# UNITED STATES PATENT AND TRADEMARK OFFICE

APPLICATION NO.	FILING DATE	FIRST NAMED INVENTOR	ATTORNEY DOCKET NO.	CONFIRMATION NO.
10/607,116	06/26/2003	Michael J. Berman	03-0538	3693

## Office Action Summary

**DETAILED ACTION**

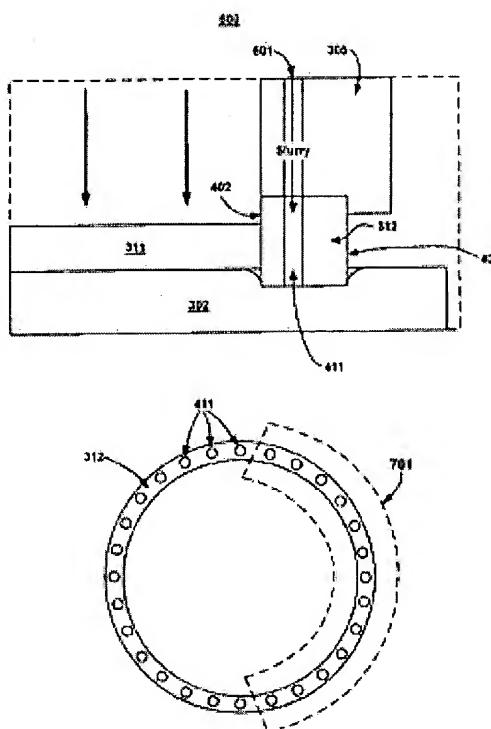
With reference to Figure 6B, col. 7, lines 47-56, Drill discloses the claimed invention except for the at least one channel in communication with the plurality of outlets 411.

With reference now to FIG. 6A and FIG. 6B, FIG. 6A shows a side cut away view of wafer 311 and dispensing ring 312, as wafer 311 and dispensing ring 312 are positioned on top of pad 302. FIG. 6A also shows an area 600, which is shown in greater detail in FIG. 6B. As depicted in FIG. 6B, area 600 shows wafer 311 receiving a downward directed force from the carrier (not shown). Wafer 311 is confined in place on pad 302 by inner radius surface 402. Dispensing ring 312 receives a downward force from arm 306 and is pressed into the resilient surface of pad 302.

In the present embodiment, arm 306 includes a plurality of slurry passages (e.g., passage 601) which align with each of the slurry dispense holes 411. CMP machine 300 pumps slurry through the slurry passages 601, through the slurry dispense holes 411, onto pad 302, and into contact with wafer 311.

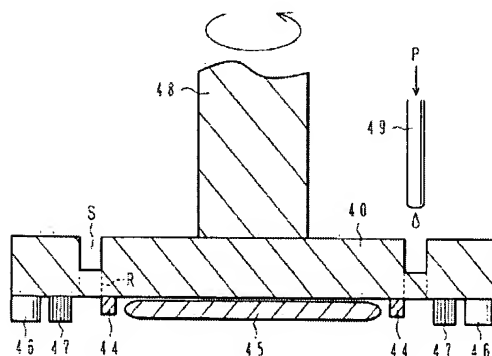
With reference to Figure 22, col. 7, lines 43-59, Tanaka teaches that it is known to have utilized at least one channel S in communication with a number of holes R so that polishing agent P can be supplied therefore from a dispensing nozzle 49 to the wafer 45 via the groove S and holes R. The advantage is to provide a uniform slurry supply to the holes.

The feature of the tool/wafer holder 40 shown in FIG. 23 is that a tool holder unit 40b with a lapping tool 46 is rotated independently from a wafer holder unit 40a with a brush 47. Specifically, the lapping tool 46 is adhered to the bottom of the tool holder unit 40b which is mounted covering the wafer holder 40b, whereas the brush 47 is adhered to the bottom of the wafer holder unit 40a. The tool holder unit 40b is rotated by a rotary shaft 48b disposed coaxially with, and outside of, a rotary shaft 48a for rotating the wafer holder unit 40a. A groove Sa is formed in the tool holder unit 40b, and a groove S corresponding in position to the groove Sa is formed in the wafer holder unit 40a. A number of holes R are formed in the groove S, opening to the bottom surface of the wafer holding tool 40a. Polishing agent P can be supplied therefore from a dispensing nozzle 49 to the wafer 45 via the grooves Sa and S and holes R.

Thus, it would have been obvious to one having ordinary skill in the art at the time the invention was made to have modified the wear ring 312 Drill with one common inlet S as taught by Tanaka in order to provide a uniform slurry supply to the holes.
